RIVERBEND CROSSING
FILING NO. 1
STREET, STORM, & STRIPING
CONSTRUCTION DRAWINGS

PCD FILE #: SF1844

STREET IMPROVEMENT, STORM SEWER, AND SIGNAGE & STRIPING CONSTRUCTION DRAWINGS

RIVERBEND CROSSING FILING NO. 1		DESIGNED BY: XXX	DRAWN BY: MGP
PEDESTRIAN RAMP DETAILS		SCALE: 1" = 10'	DATE: 10/17/20
		JOB NUMBER	SHEET
		17-114	21 OF 21

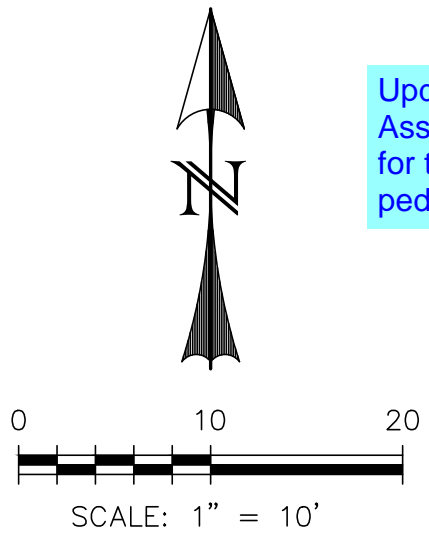
S=2.6%.
Does not meet criteria. The slope of the landing in any direction shall not exceed 2% (ECM Section 6.3.1.G.5).
Check all other landing pads and adjust.
Update all landing pad slopes to identify the max slope.

Update Financial Assurance Estimate for the quantity of pedestrian ramps
